Addendum 2 for RFB 943500-01

Project Name: DNR HCR Hotel Roof Replacement
RFB#943500-01
DAS Project #: 9453.00
Date: 4/18/2025

Addendum #02: Meeting Minutes, Procurement Questions & Document Changes

8 RIDGE DETAIL @ AREA A AND C1
SCALE: 1 1/2" = 1'-0"

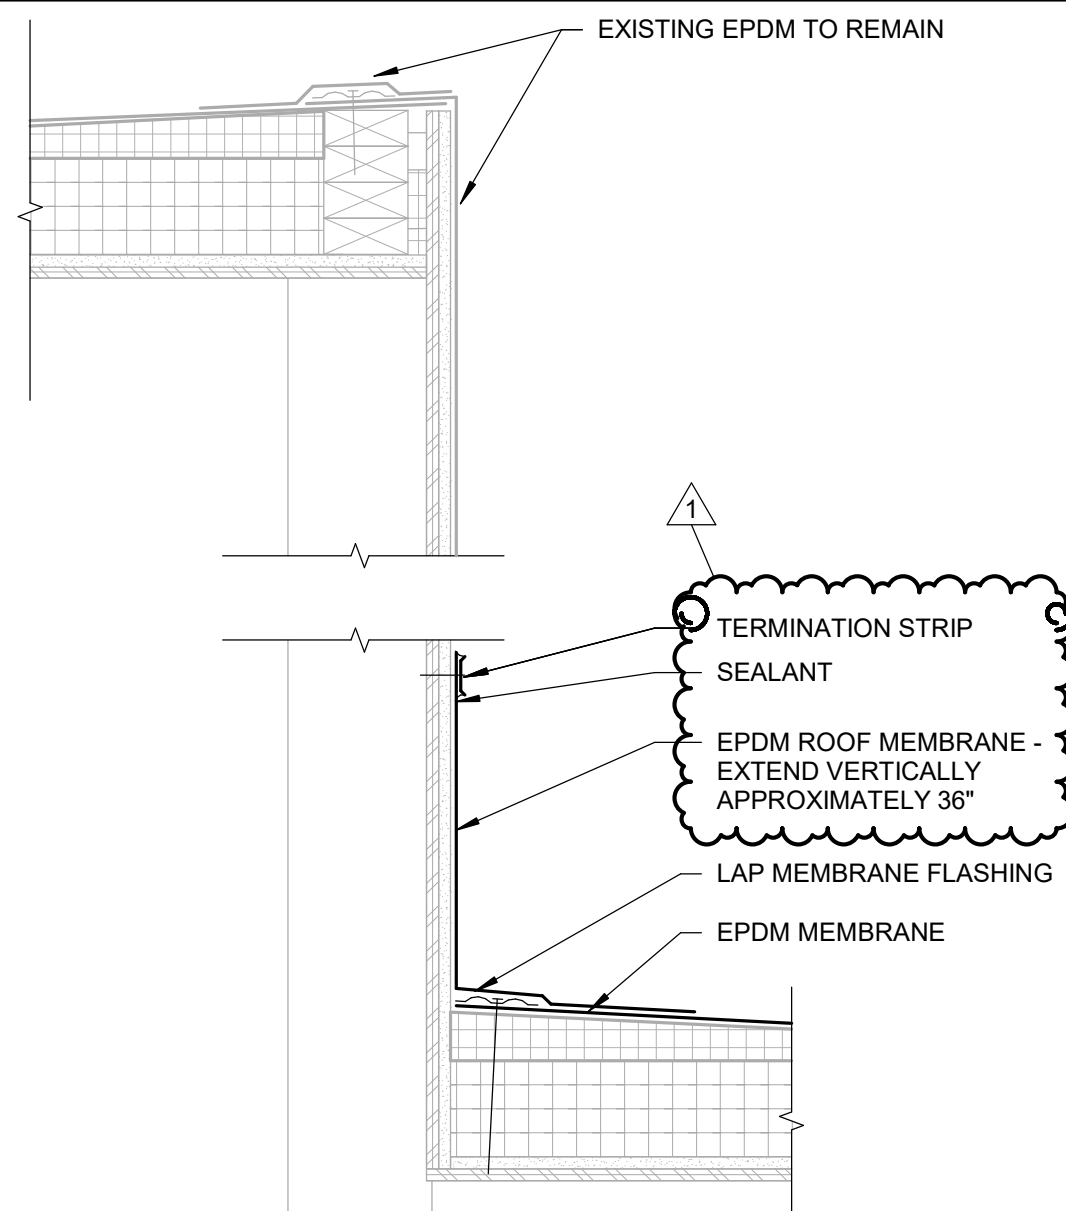
1. CHANGE ridge detail callout to 8/A7.2 at Area C1.
2. ADD ridge vents on small dormer roofs as part of Alternate No. 1.

1. CHANGE ridge detail callout to 8/A7.2 at Area A.
2. ADD ridge vents on small dormer roofs as part of Alternate No. 1.

1. Detail 1: REVISE vertical extents of new membrane roof.
2. Detail 2: CLARIFY existing roof ventilated nailbase insulation system as shown in existing drawings.
3. Detail 4: REVISE vertical extents of new membrane roof.
4. Detail 6: CLARIFY existing roof system. ADD coverboard and plywood to infill scope.
5. Detail 7: CLARIFY existing roof ventilation as shown in existing drawings.
6. Detail 8: ADD existing ridge roof ventilation detail as shown in existing drawings.

1 ROOF EDGE
SCALE: 1 1/2" = 1'-0"

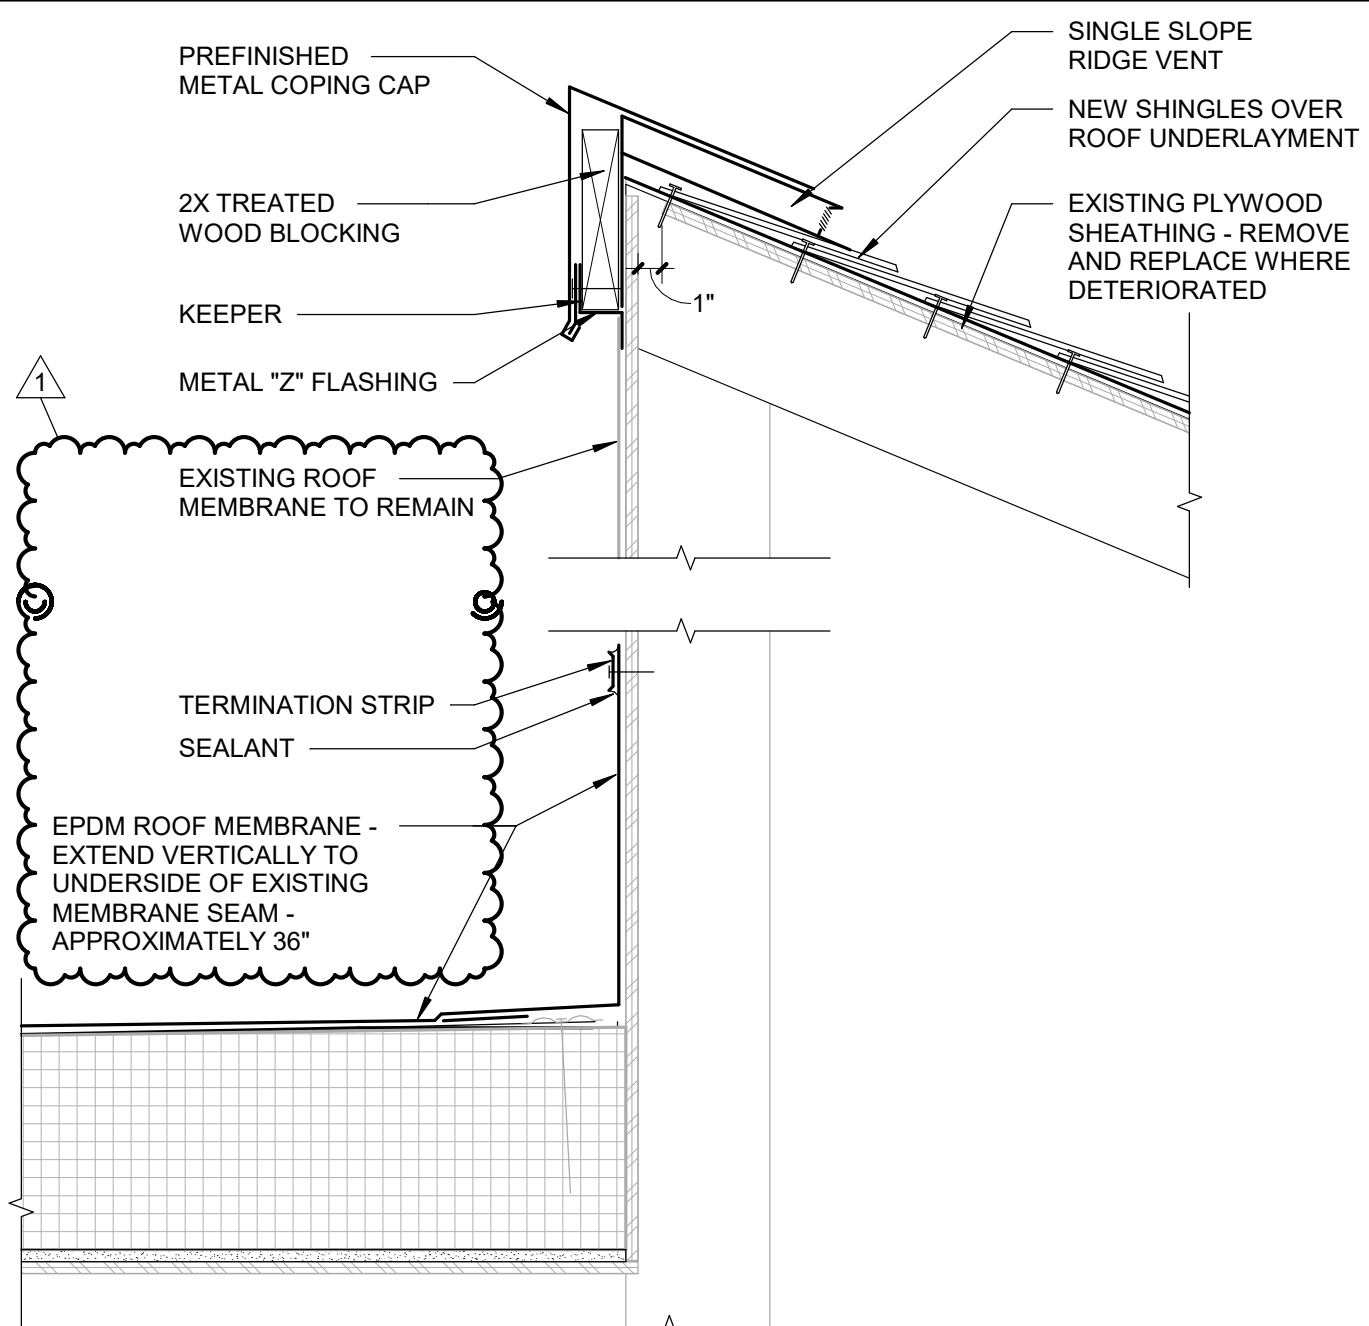
- Confirm ventilation around C2 if the A7.2/ Detail 1 is necessary due to the fact of vent grates on the interior parapet walls.
 - louver vents are not shown on original drawings, the original details show a vent in the cap – which is not there now.
